2.0 EIS Addendum

This chapter contains specific modifications and updates to the Project Draft EIS published in June 2012. These revisions were made in response to comments received during the 45-day public comment period from June 1 through July 17, 2012. **Table 2-1** identifies the text revisions. Where text has been modified or added, the new text appears in **bold italic** print. Deleted text appears with a ~~strikeout line~~ through the text. Revised tables are presented in their entirety following **Table 2-1**.

Hollister Underground Mine Project EIS

Figure 3.4-4

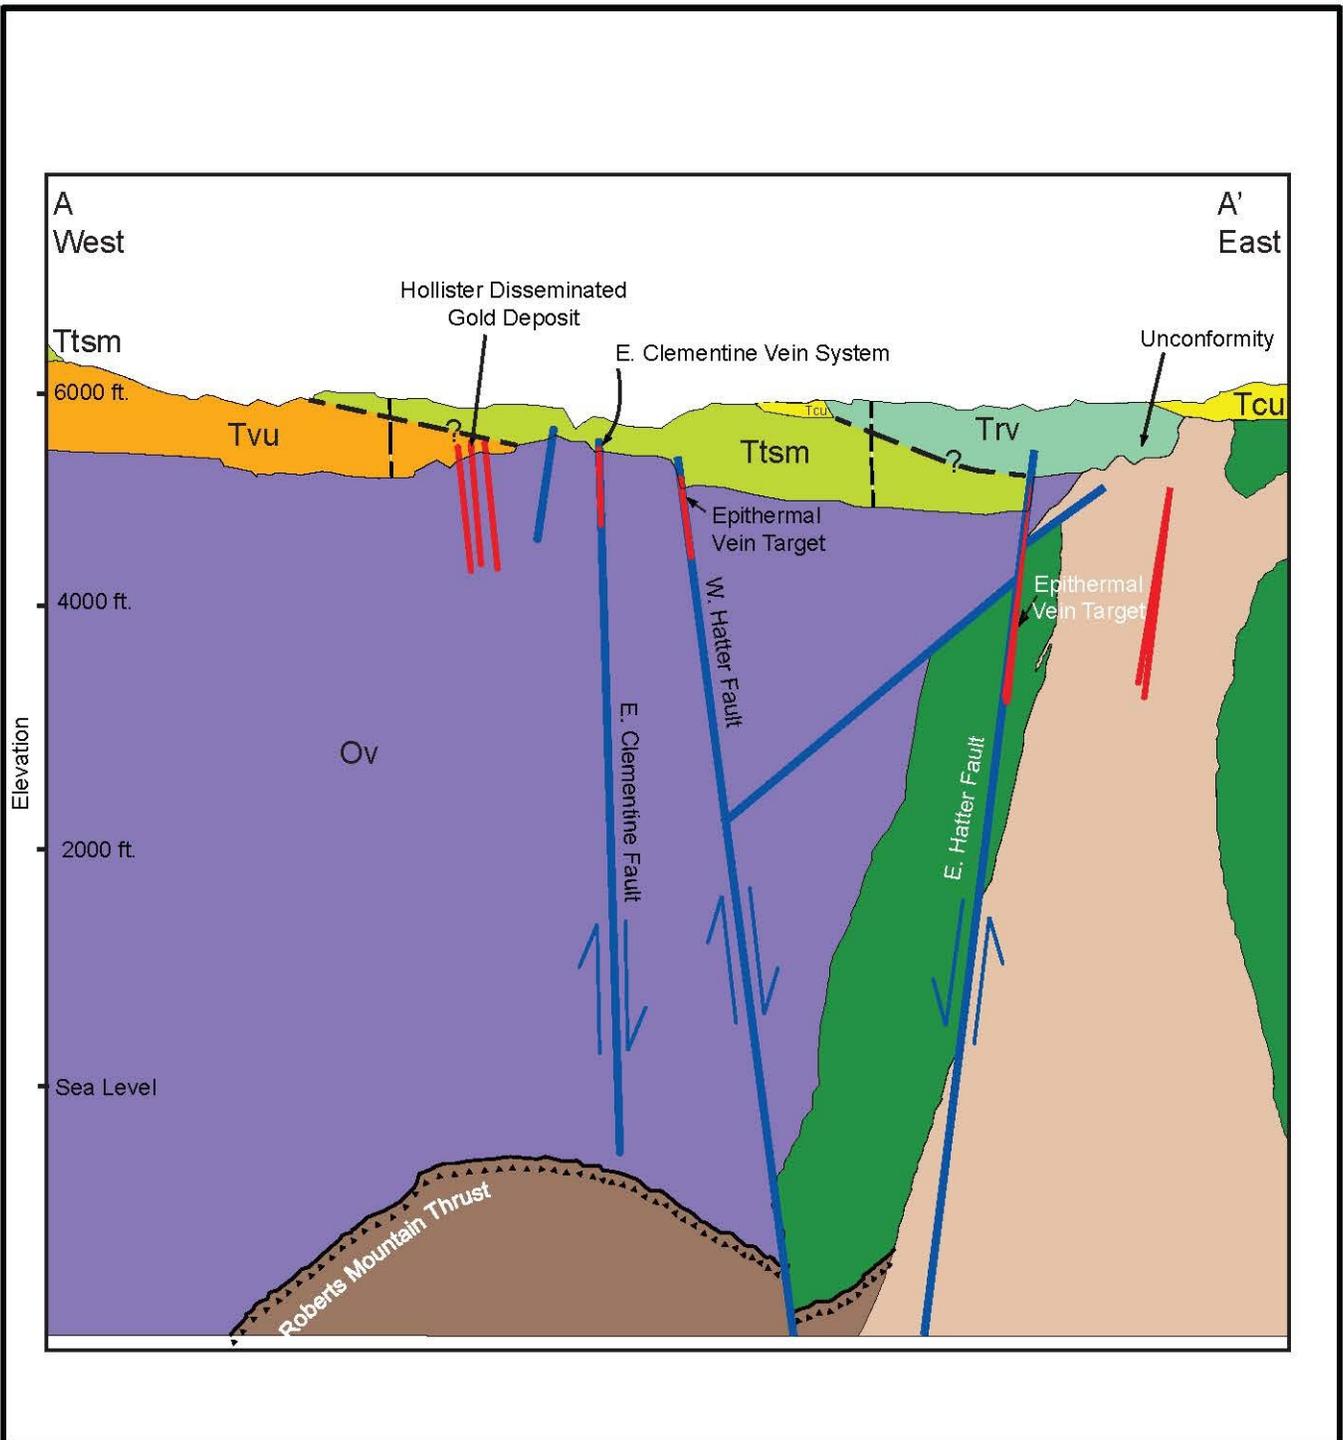
Note: The cross-section, A-A' is shown on Figure 3.4-1 of the DEIS. Mining disturbance not shown.
 Sources: RCG 2011b, Wallace 2003a.
